## ACTIVITY DETERMINATION

Project No. BGGXT

Demolition of an existing dwelling and associated structures, removal of trees, and the construction of an 18 dwelling seniors housing development comprising 12 x 1-bedroom and 6 x 2-bedroom independent living units with associated landscaping and fencing, surface parking for 9 cars, and consolidation into a single lot.

TITLE: <b>SITE PLAN INCLUDING ACCESS TO BUS STOP ON BRANSGROVE RD &amp; PROPOSED PRAM RAMP CONSTRUCTION ON POLO ST CNR</b>	
FILE: BGGXT_A14	PLOTTED: 23 MARCH 2022

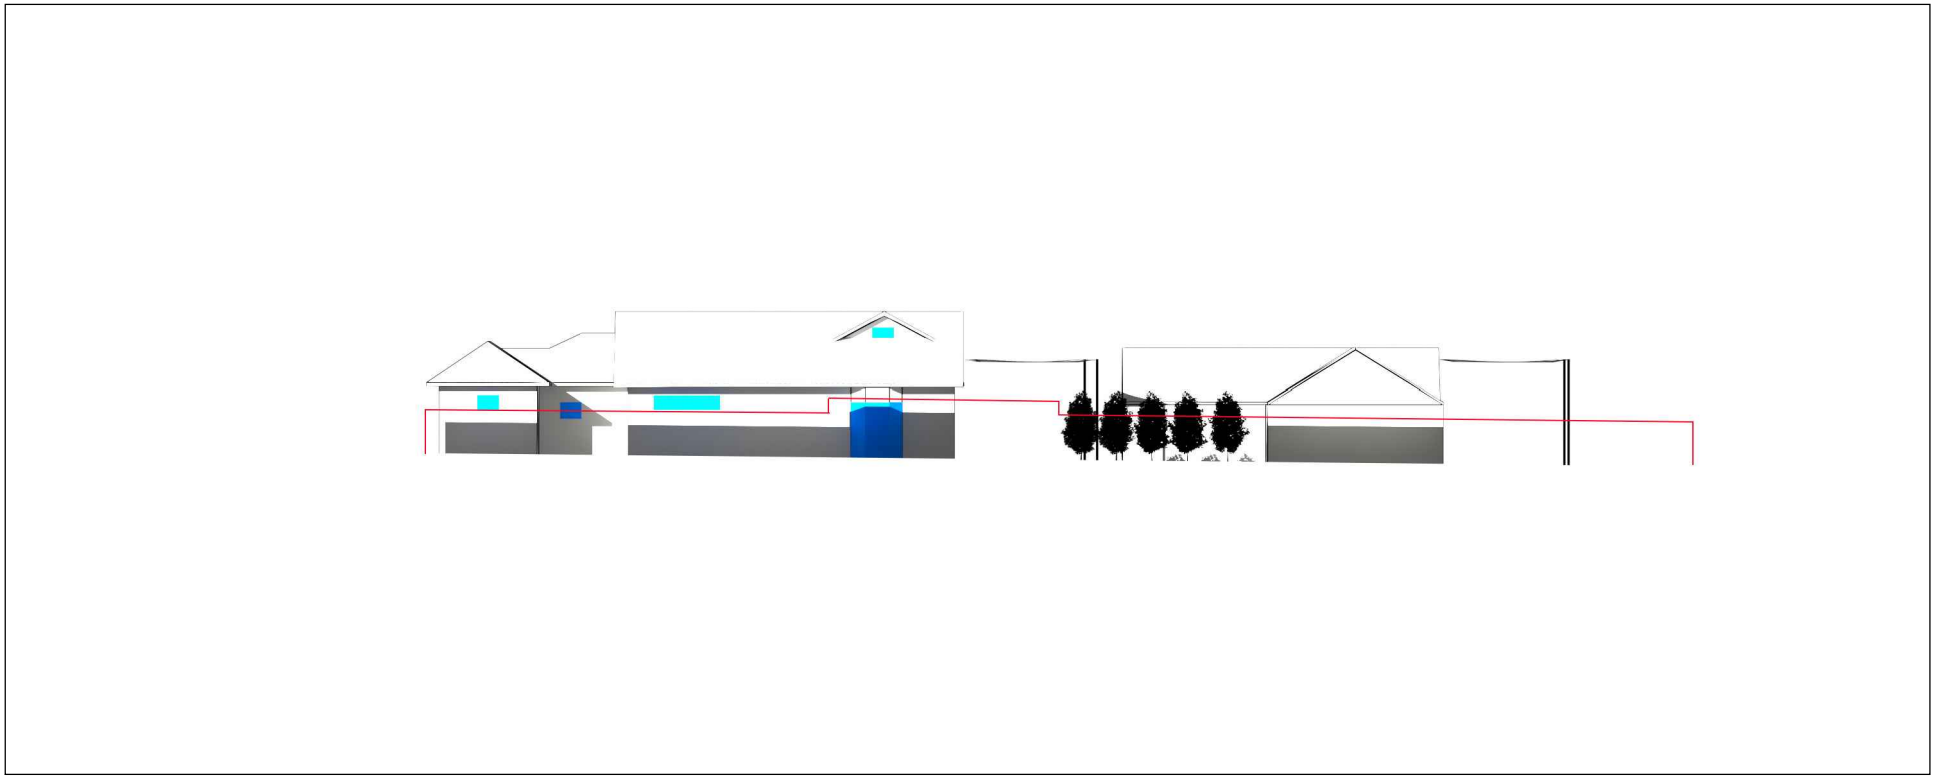
80. **Pram ramp at the northern side of Polo Street near the intersection with Bransgrove Road** – as identified in the Access Report, the pram ramp is to be upgraded in collaboration with the City of Canterbury Bankstown Council and the relevant road authority (if not City of Canterbury Bankstown Council) to provide a continuous accessible path of travel between the site and the nearest bus stops.
